# MANUAL CHANGES

**Model Number:** 8620C
**Date Printed:** OCTOBER 1977
**Part Number:** 08620-90093

18 JUNE 1981
14 pages plus 3 foldouts

*Figure 1. Location of CW Filter Capacitor Jumper on A3 Logic Assembly*

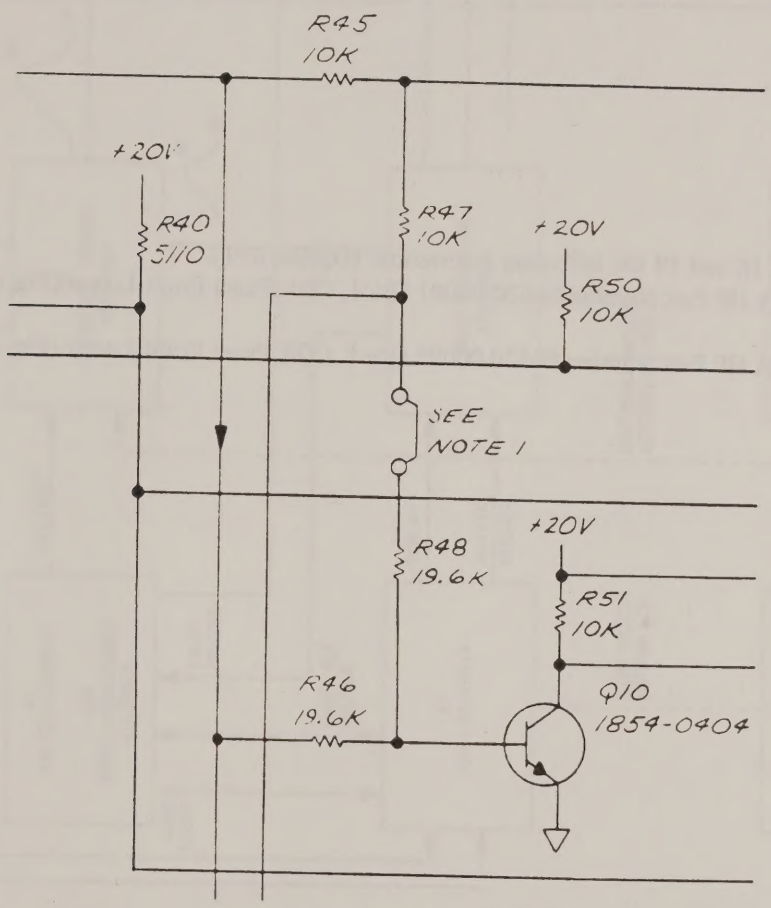
Delete C4.
Add jumper to A3 Logic Assembly schematic as shown in partial schematic, Figure 1.
Change R17, R18, and R19 to 196.
Change R27, R28, and R29 to 196K.
Add NOTE 1 to schematic diagram as follows:

NOTE 1. CW FILTER CAPACITOR JUMPER FOR REMOTE DIGITAL MODES. NOT INSTALLED AT FACTORY. THE FOLLOWING TABLES INDICATE THE STATUS OF THE CAPACITOR WITH AND WITHOUT THE JUMPER INSTALLED.

*Figure 8-9. Functional Block Diagram (ERRATA)*

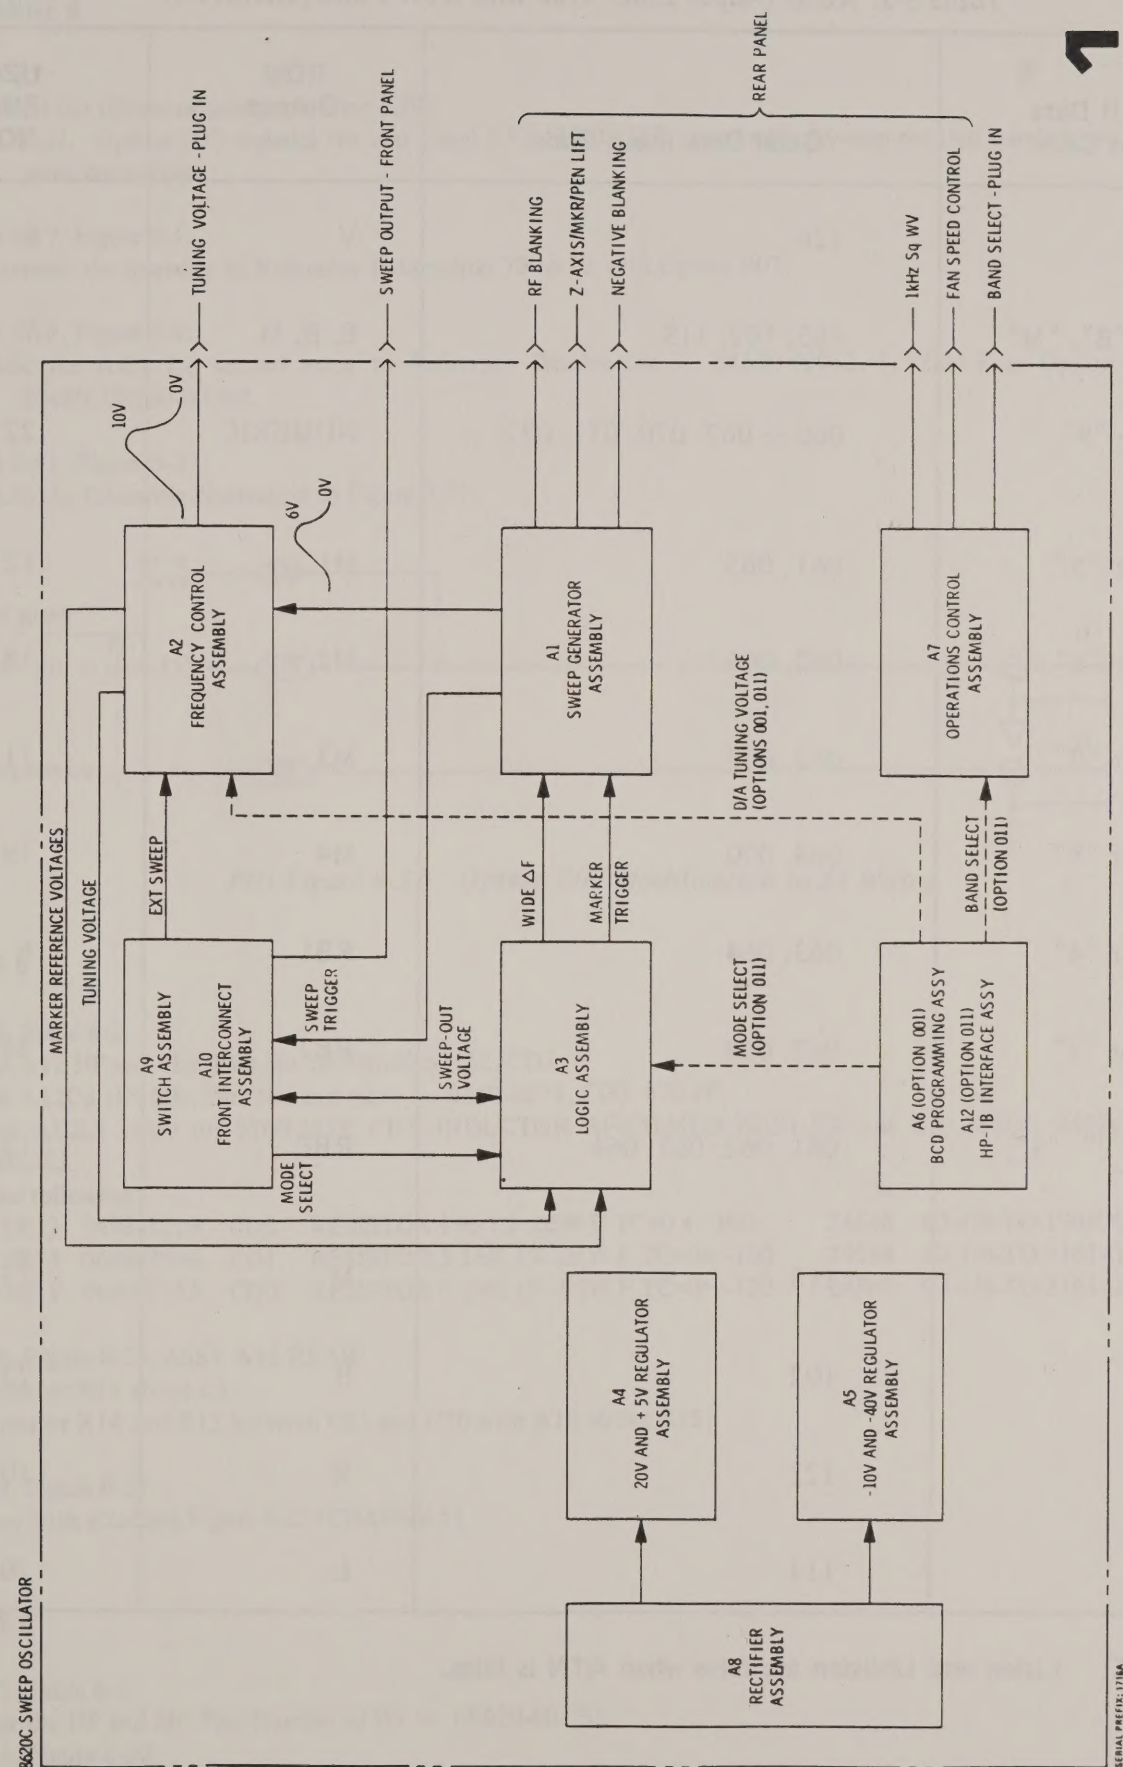
Page 8-13, Figure 8-9:
Replace Figure 8-9 with Figure 8-9 (ERRATA) of this change sheet.

*P/O Figure 8-37. Option 007 Modification to J4 Wiring*

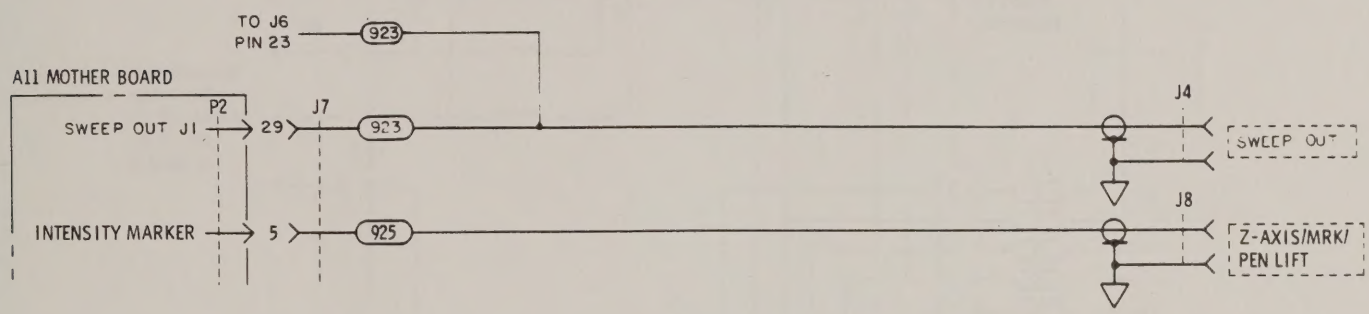
Page 1-7:
Insert the following paragraph after 1-29:
1-29. Option 007 replaces the rear panel EXT. TRIGGER input with a Sweep out that parallels the front panel connector.

Page 8-41, Figure 8-37:
Add the following illustration to Figure 8-37:

*Figure 2. Primary Power Wiring*

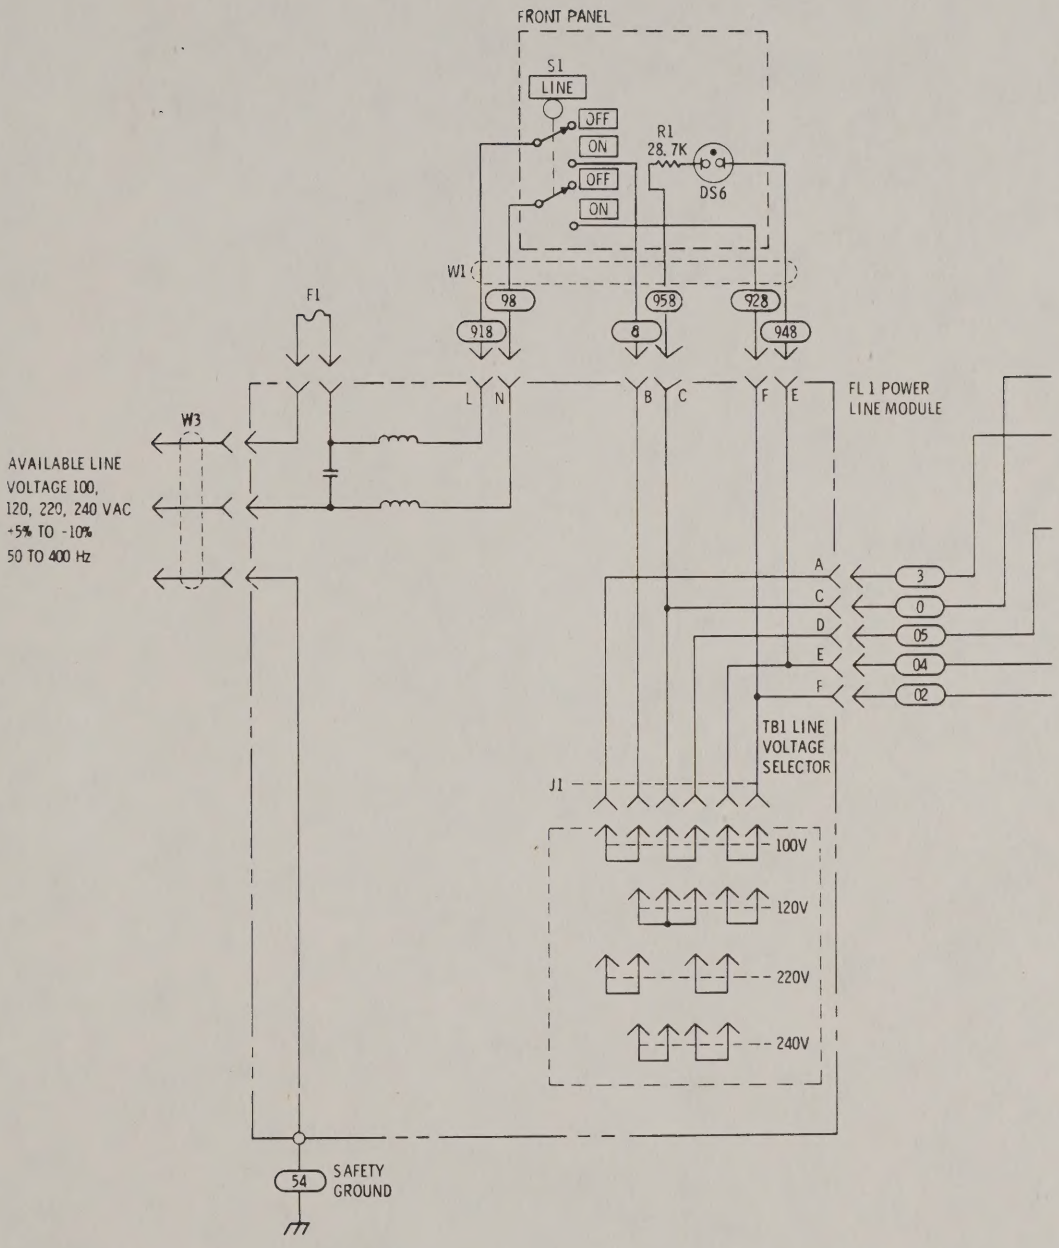
Page 6-15, Table 6-2:
Change the HP and Mfr Part Number of W1 to: 08620-60170.
Page 8-33, Figure 8-30:
Replace the primary portion of Figure 8-30 with Figure 2 in this supplement.
